## 2 Type of change

- Modified packaging label
- Improved identification: product configuration code on the label

Product Change Notification					PG10 Global Labeling change		
owner	creation date	release date	released by	change order no	rev	page	D10-056-044
helbijo	12.03.2021	15.03.2021	barthro	2021671	A	1 of 2

Old packaging label (all product types)	New packaging label (all product types)

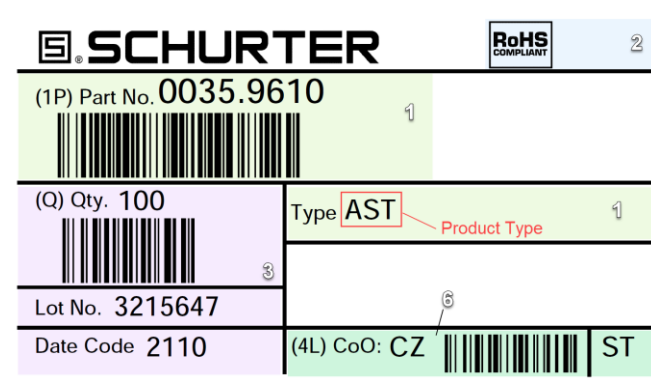
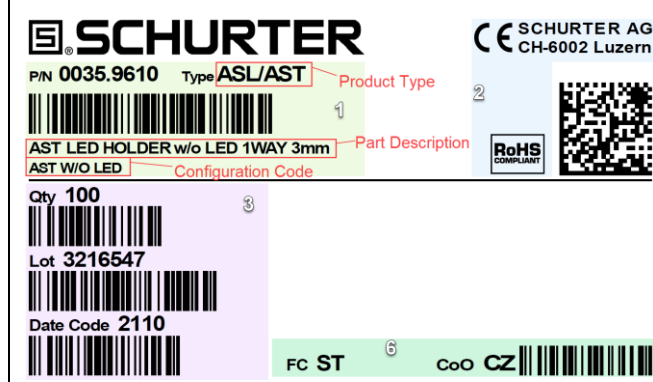
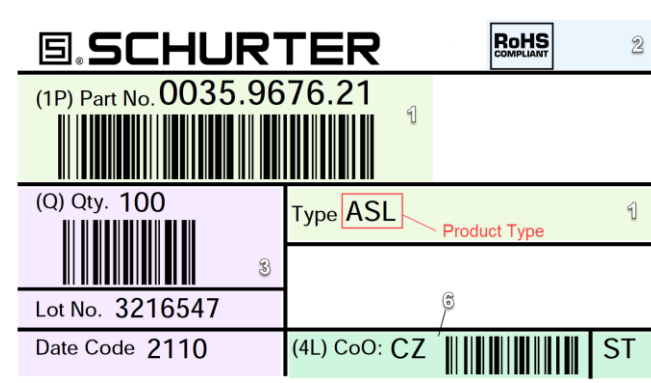
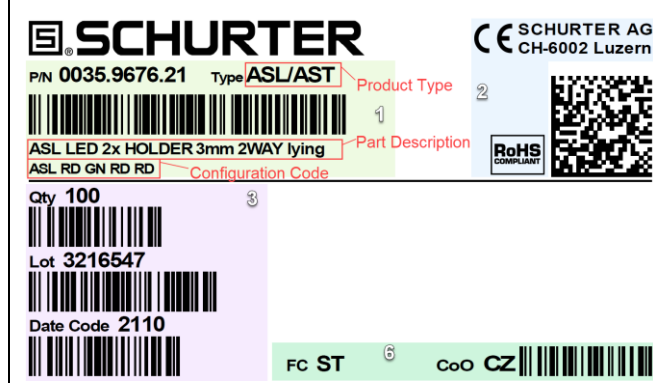
The following table describes the modifications applied to the new packaging label. All listed product types share the same packaging label design. To better visualize the modifications, colours and numbers were added to this chapter to cluster information into sections (the colours and white numbers are therefore not part of the new label layout). Some old and new label have been added as an example for visualization.

**Product identification section:** To improve readability, all the information concerning product identification in this group is clustered. Furthermore, some of the content/ text of the label is subjected to following changes (see highlighted red areas on the labels of the following page):

- Product Type: Not changed.
- Configuration Code: Has been added.
- Part Description: Has been added.

**Product conformity section:** Identical information, slightly rearranged. CE and SCHURTER address added.

**Product logistics section:** Identical information, slightly rearranged.

**Origin information section:** Identical information, slightly rearranged. Factory Code identifier "FC" added.
